Project	IEEE 802.16e Broadband Wireless Access Working Group < <u>http://ieee802.org/16</u> >
Title	Fix for ARQ Reset flow charts
Date Submitted	2006-07-06, Version: 1.0
Source(s)	Nadav LaviNadav.Lavi@alvarion.comAlvarion Ltd.
Re:	Call for Maintenance Change Requests on IEEE Std 802.16
Abstract	This document suggests changes in TGe Draft Document IEEE 802.16e-2005 to fix ARQ Reset flow charts
Purpose	Adopt into the current Maint TG draft
Notice	This document has been prepared to assist IEEE 802.16. It is offered as a basis for discussion and is not binding on the contributing individual(s) or organization(s). The material in this document is subject to change in form and content after further study. The contributor(s) reserve(s) the right to add, amend or withdraw material contained herein.
Release	The contributor grants a free, irrevocable license to the IEEE to incorporate material contained in this contribution, and any modifications thereof, in the creation of an IEEE Standards publication; to copyright in the IEEE's name any IEEE Standards publication even though it may include portions of this contribution; and at the IEEE's sole discretion to permit others to reproduce in wh

Figure 34-ARQ Reset message dialog-transmitter initiated

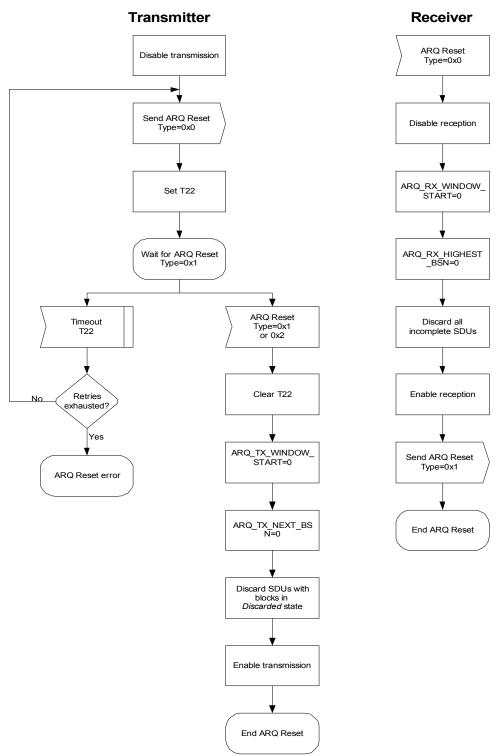
Figure 34 in 802.16e-2005 is incomplete:

resetting of parameters ARQ\_TX\_NEXT\_BSN and ARQ\_RX\_HIGHEST\_BSN is missing

[At the page 177 of 802.16e-2005 replace Figure 34 with the following figure]

Figure 35-ARQ Reset message dialog-receiver initiated

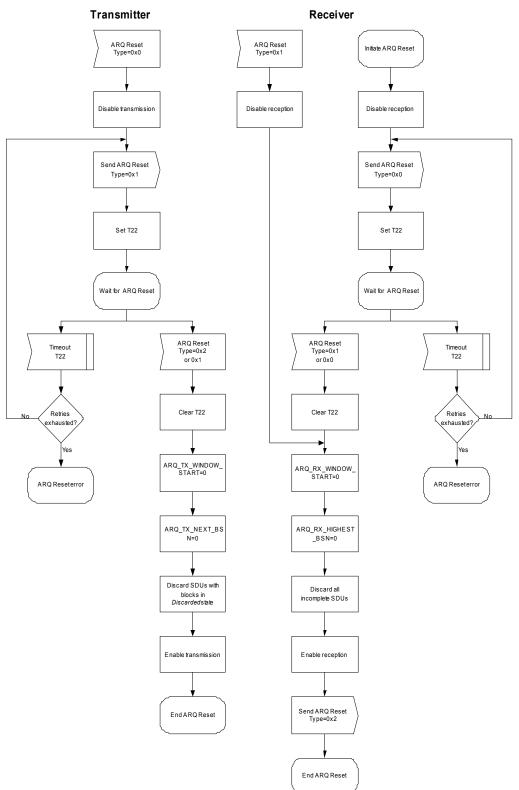
Figure 35 in 802.16e-2005 is incomplete and contains errors:

resetting of parameters ARQ\_TX\_NEXT\_BSN and ARQ\_RX\_HIGHEST\_BSN is missing

[At the page 178 of 802.16e-2005 replace Figure 35 with the following figure]
